Docket Item # 10
BAR CASE # 2007-0198

BAR Meeting
November 14, 2007

ISSUE: Addition and alterations
APPLICANT: James & Judith Blaha
LOCATION: 722 S. Royal Street
ZONE: RM/Residential

Figure 1: proposed east elevation

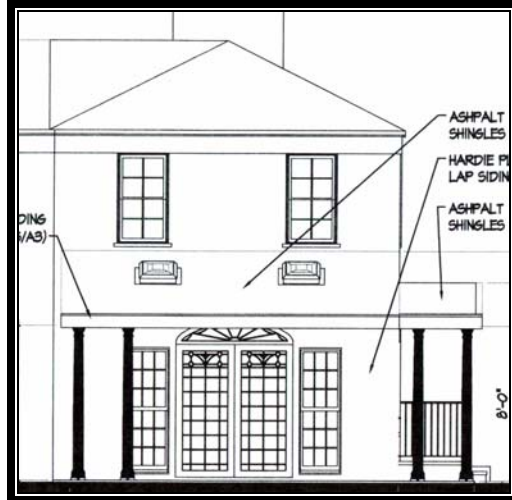
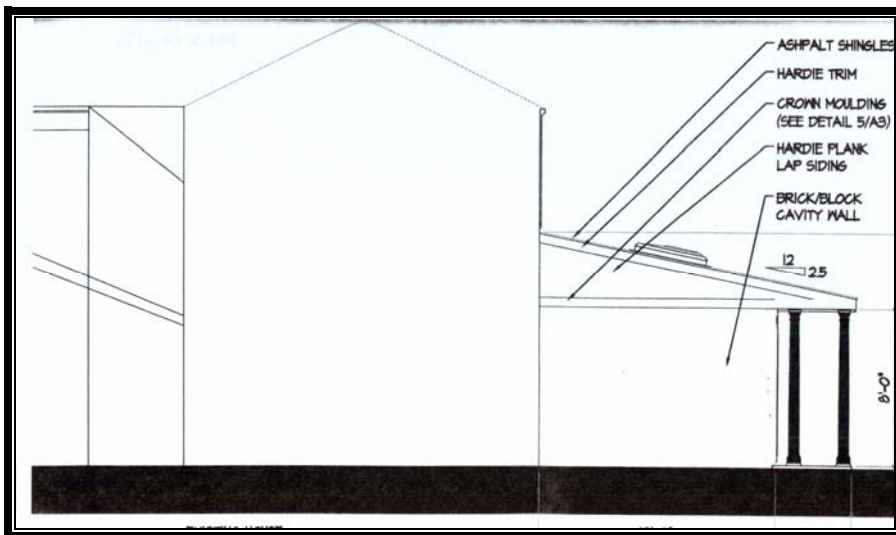
Staff has no major objections to the proposed addition and believes that it complies with the *Design Guidelines* for residential additions. It is modest in size and will not be readily visible from the public right-of-way. A number of features of the addition, such as the domed skylights, vinyl clad windows and door and fiberglass columns would not be acceptable if they were in a more visually prominent location. The skylights are not expected to be visible from the public right-of-way. As discussed above, the north side of the addition will be minimally visible. The addition is set back at least 45' from the public-right-of-way. For this reason and because they are part of a new construction project, Staff is willing to accept the vinyl clad windows and door and fiber glass columns on this elevation, although wood is preferable. With respect to the use of fiber cement siding, the Board has adopted the following policy:

The use of fiber cement siding is appropriate in this case as it is to be used on a new addition. The applicant has specified that the siding will have a smooth finish. Staff notes that, in accordance with the policy, item #4, the nails must not show in the installation of the siding.

1. That the Hardiplank siding be installed so that the nails do not show; and,
2. That the following statements shall appear in the General Notes of all site plans and on all site plan sheets that involve demolition or ground disturbance (including Erosion and Sediment Control, Grading, and Sheeting and Shoring) so that on-site contractors are aware of the requirements. Additional statements to be included on the Final Site Plan will be determined in consultation with Alexandria Archaeology:
